15401 – Service Update for Inventory and Customer Vehicles — Front Driver and Passenger Seat Plate Nut Thread Quality — Expires with Base Warranty

2015 Buick Enclave

2015 Chevrolet Traverse

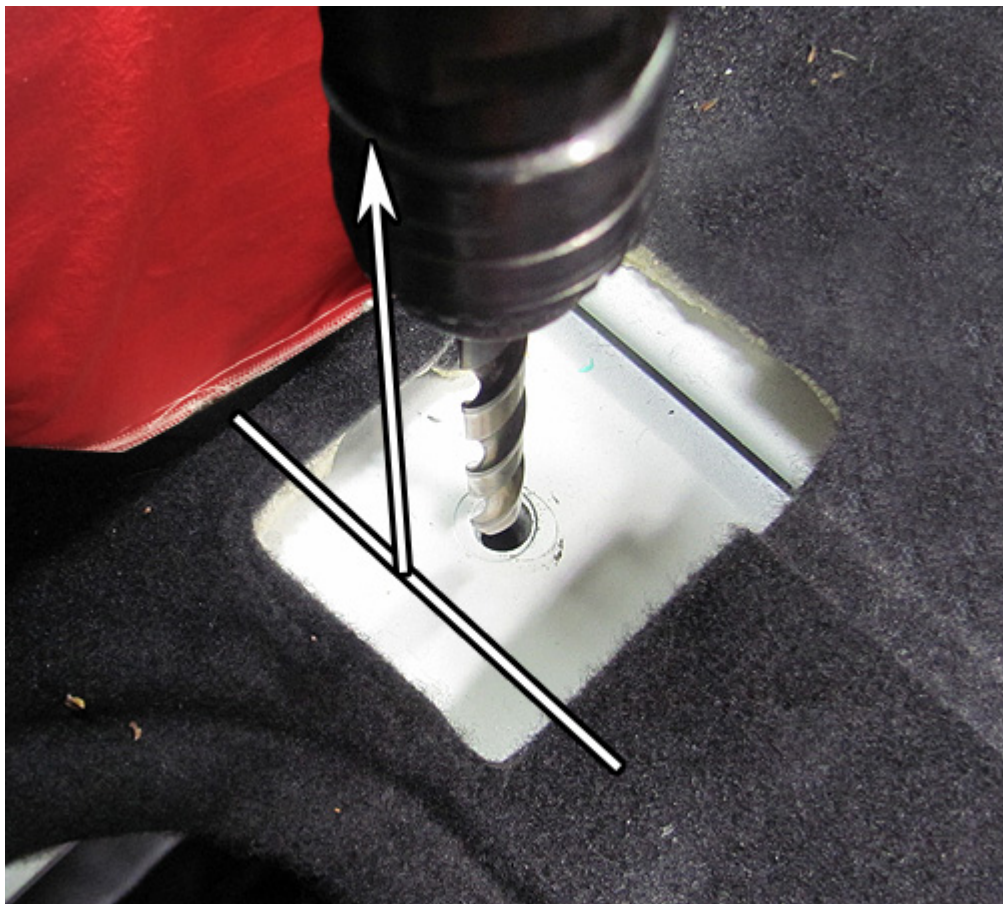
Discard the two inboard mounting bolts. Install two new 12mm bolts (1). Reuse the outer track bolts. Apply thread locker to the outer track bolts (2).

Use only hand tools to install fasteners. Do not exceed 25 Nm (18 lb-ft) force during installation.

Install the front seats using the two new inboard bolts (1).

6. Apply thread locker to the outboard bolts (2) being reused before installing them.
7. Torque all fasteners to 45 Nm (33 lb-ft).
8. Finish installing both front seats. Refer to in SI.
9. Return seats to original positions.

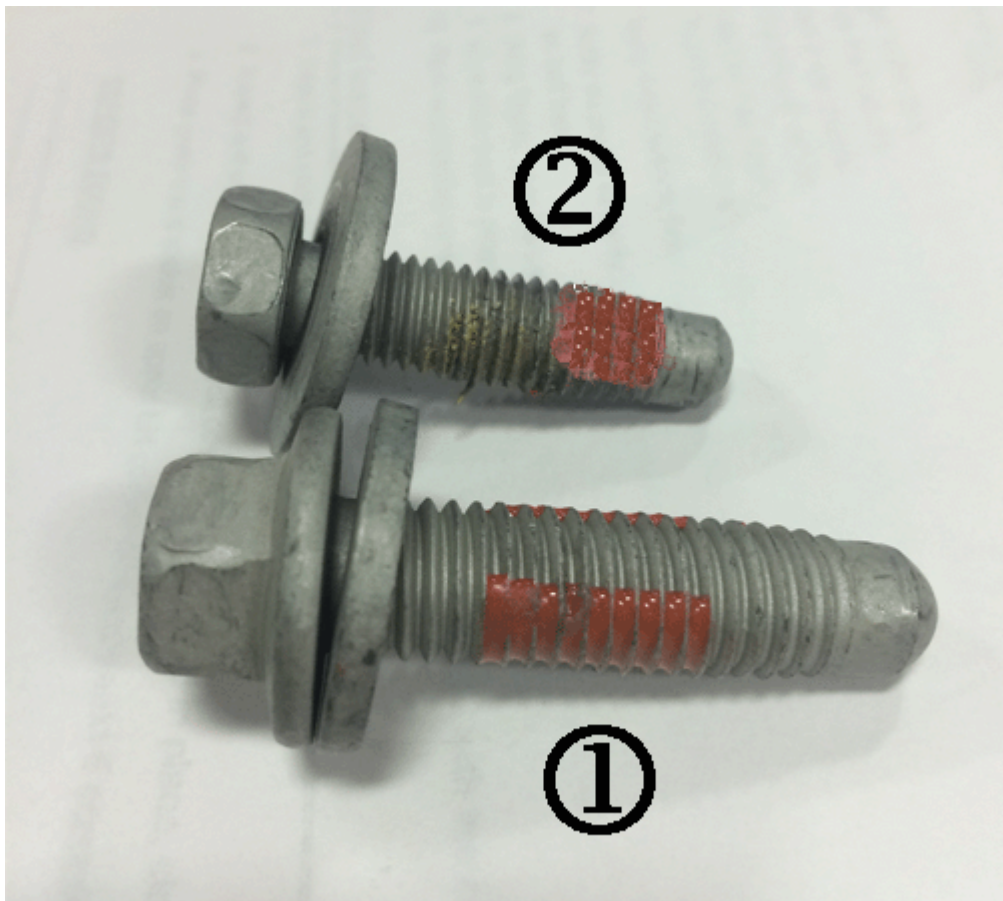
Enlarging the holes requires drilling close to the center console. Use a compact drill to maintain a vertical drilling angle aligned to the holes.

Drill out the inboard seat track bolt mounting holes closest to the center console (one per seat) using the 11mm (7/16") drill bit keeping square to the holes.
